**T e r r e b o n n e P a r i s h C o n s o l i d a t e d  
G o v e r n m e n t**

**T P C G S t r e e t L i g h t i n g**

**A d d e n d u m # 1**

**Subject:** TPCG Street Light Replacement

**ATTACHMENT A**

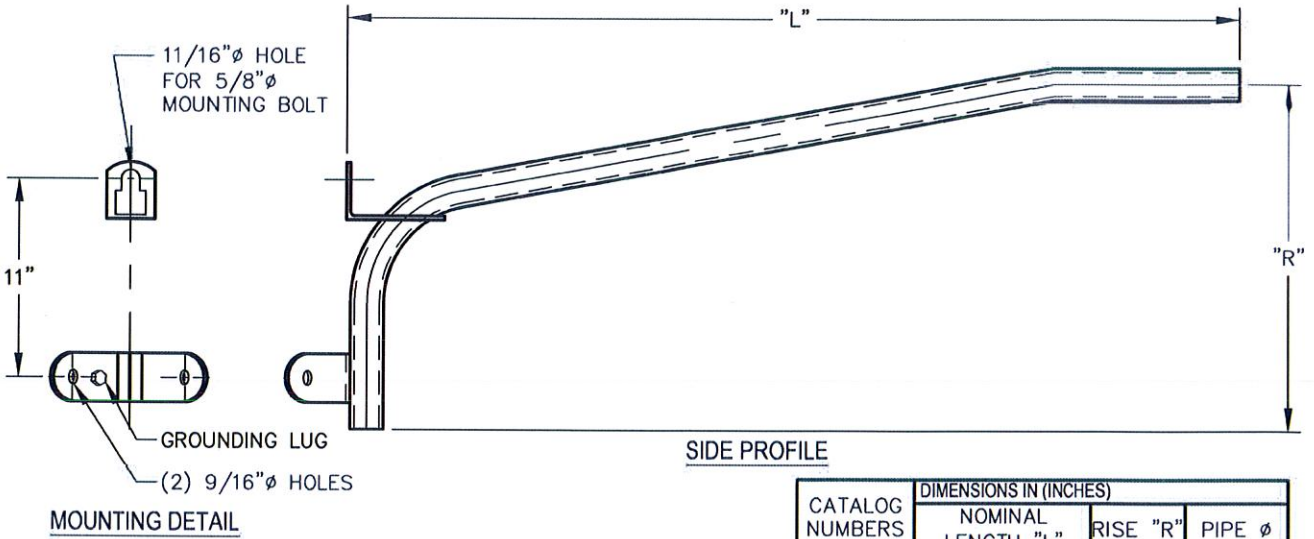
24) Question - Attachment E Major Material Data – appears to be somewhat deficient in materials to be covered by Parish, need more information.

**Answer – Exact part numbers for all materials are unavailable and due to the quantity required specific part numbers will change as “or equals” are used to maintain the project schedule.**

**Typical part numbers for the fixtures, a typical aluminum pole drawing, and the following statement will be added to Attachment E for clarification.**

**“All structures and electrical materials to be permanently installed will be considered major material items and provided by the owner. All installation consumables, temporary items, backfills, concrete, access or repair materials will be contractor furnished and included in the bid units.”**

Below are the typical fixtures to be used in this project. Exact fixtures to be used on each location may be an "or equal" to these items. Available cut-sheet will be provided in this section for contractor reference.
